Access Compliance Report

Public Rights-of-Way

(Curb Ramps)

Intersection ID: 48952	Main Street: BREVERA_CR	Cross Street: BONROI_AV	Location:	N
ADA ID: 0047114D0A27	Ramp Type: Perp	Initial Pass/Fail: Fail	Overall Compliance: No	Severity Score: 10

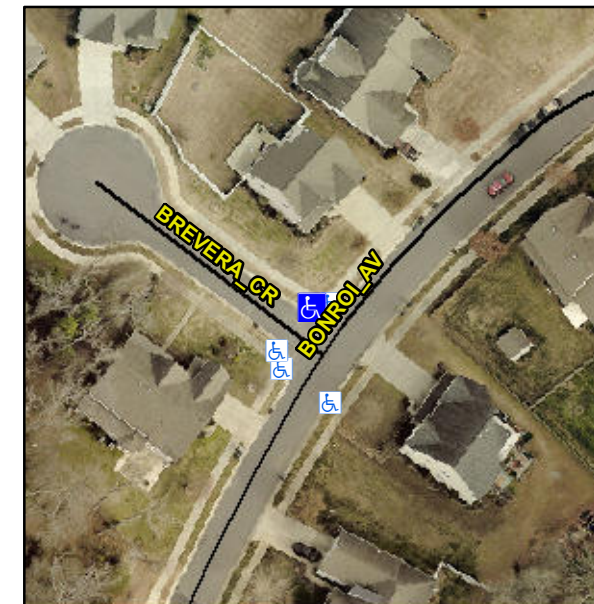
Not Found, R304.5.1, R304.5.3

Compliance	Description	Data	Compliance	Description	Data
N/A	Ramp Length (in)	50.0	Yes	Ramp Slope (%)	7.7
No	Ramp Width (in)	47.0	No	Ramp XSlope (%)	2.5
N/A	Flare Type LT	N/A	N/A	Flare Type RT	N/A
N/A	Flare Slope LT (%)	N/A	N/A	Flare Slope RT (%)	N/A
N/A	Flare Traversable LT?	N/A	N/A	Flare Traversable RT?	N/A
N/A	Landing Length (in)	N/A	N/A	DWS Provided?	N/A
N/A	Landing Width (in)	N/A	N/A	DWS Contrast?	N/A
N/A	Landing Slope (%)	N/A	N/A	DWS Length (in)	N/A
N/A	Landing X Slope (%)	N/A	N/A	DWS Full Width?	N/A
N/A	Landing Curb? (Y/N)	N/A	N/A	DWS Offset (in)	N/A
N/A	Shared Landing?	N/A			
N/A	Gutter Ponding?	N/A	N/A	Gutter Slope (%)	N/A
N/A	Gutter Lip Ht (in)	N/A	N/A	Gutter X Slope (%)	N/A
N/A	Painted X Walk1?	No	N/A	Painted X Walk2?	N/A
	X Walk 1 Direction	To SW		X Walk 2 Direction	N/A
N/A	X Walk 1 Width (in)	N/A	N/A	X Walk 2 Width (in)	N/A
	X Walk 1 Slope (%)	0.2		X Walk 2 Slope (%)	N/A
	X Walk 1 X Slope (%)	0.8		X Walk 2 X Slope (%)	N/A

Remove & Replace Entire Ramp.
